Dr. Yoram J. Kaufman

December 7, 1993

Water vapor filters

US Standard Atmosphere (ZA=60)

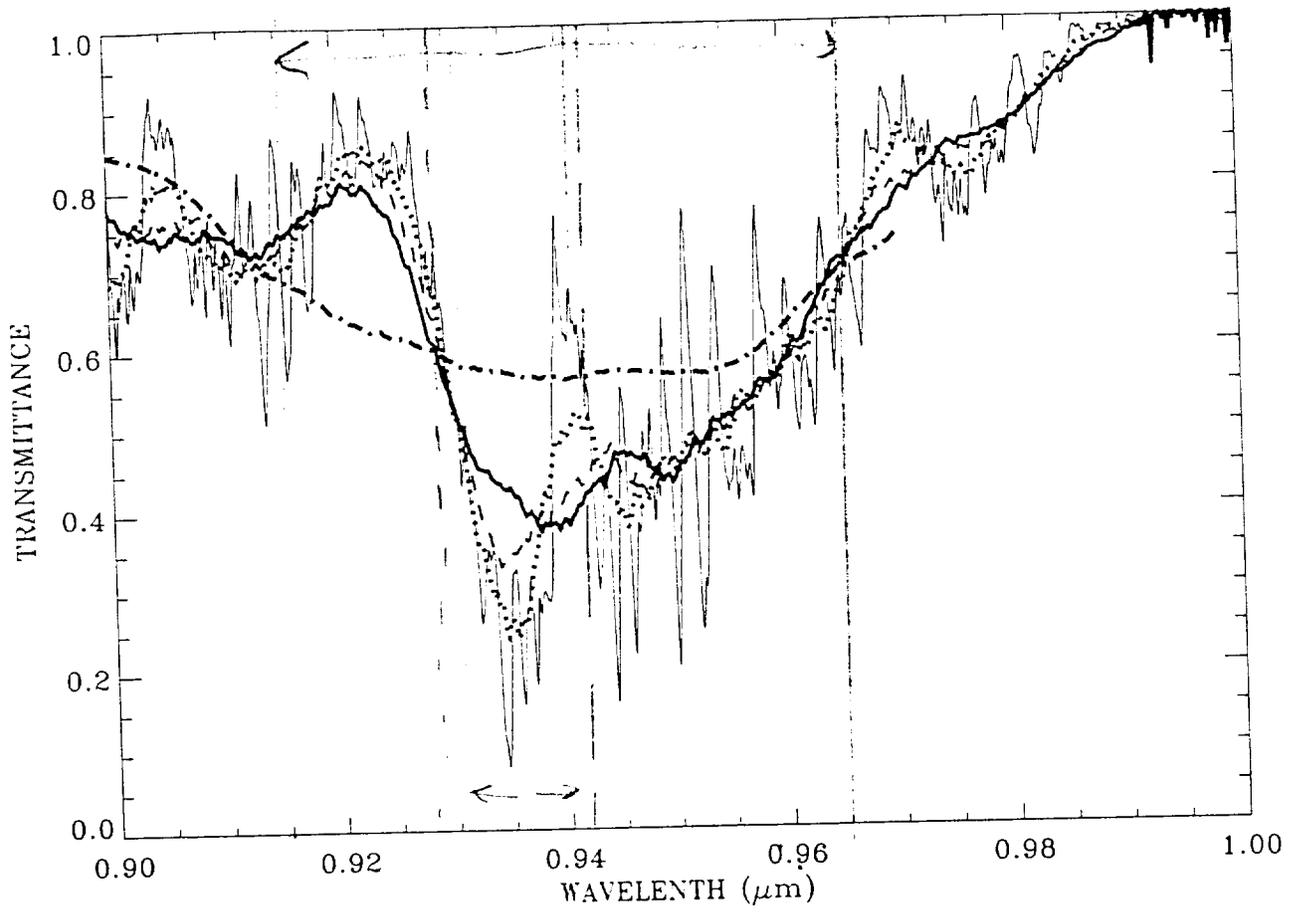
Question: Is the new location of channel 1⁹ (940±25 nm) acceptable?

Answer: If the position will remain the same in space than Yes

If in space will be shifted by 5 ± 3 nm than the remote sensing error will increase substantially and the answer is probably no. We planned to have an error of 5% in the retrievals. Part of the error will translate to systematic error in the retrieval and part non systematic increasing the residual error to 7-9%.

Central wavelength (nm)	transmission (US std. 1.4 cm water 60 view)	Error in Transmission due to a shift of 3 nm to shorter wavelength	error/signal in %	
945	0.562	0.001	0.2	
Original	940	0.56	0.003	0.7
new	935	0.571	0.004	0.9
If shifted by 5 nm	930	0.585	0.026	6.3
